RE: MIRANDA DENTAL HOSPITAL – STREET ACCESS TO MAIN ENTRANCE

I refer to your request for an assessment of compliance for the proposed entrance way to this tenancy from the footpath off Kiora Road.

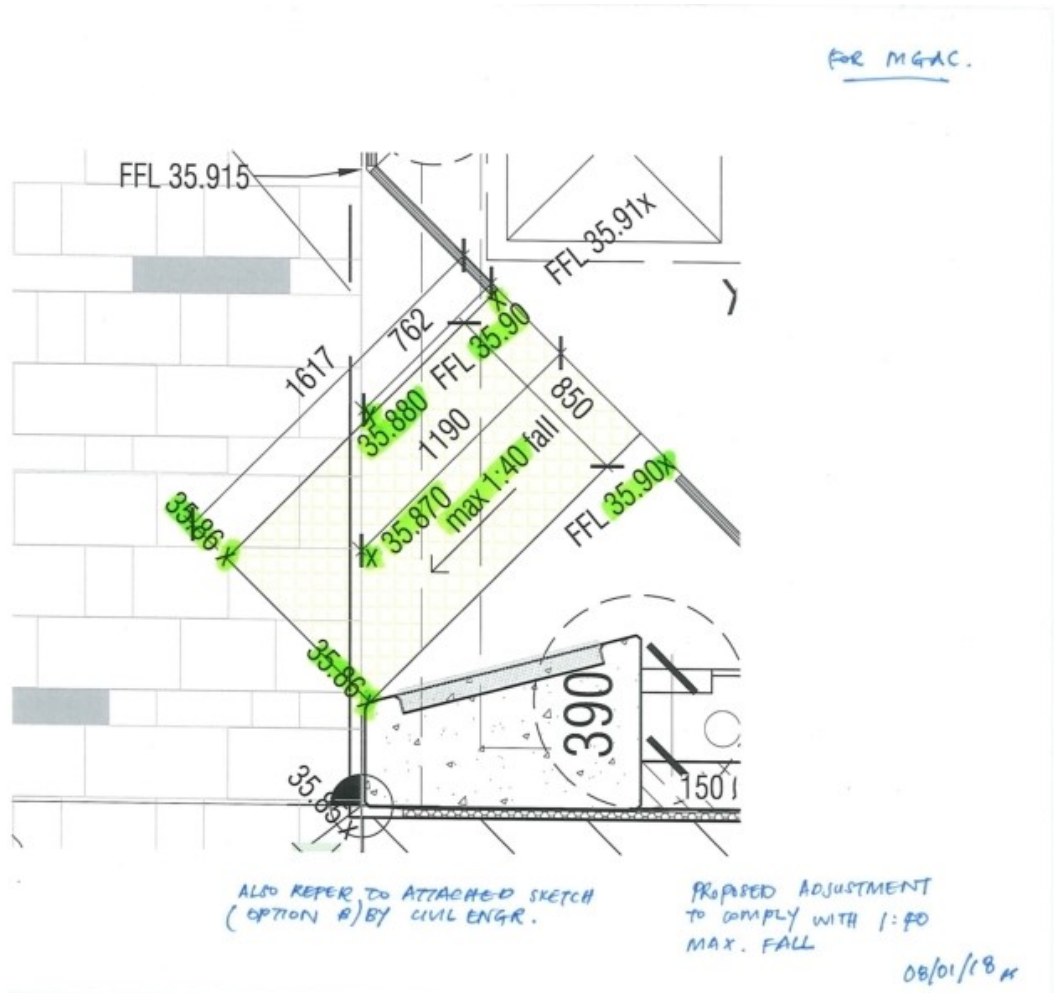
I confirm that the entrance off Kiora Road will comply with the provisions of AS1428.1 provided that:

- It is constructed as per the levels shown in the attached sketch and
- And the entrance door is fitted with an auto sensed power opened door achieving 850mm clear opening width.
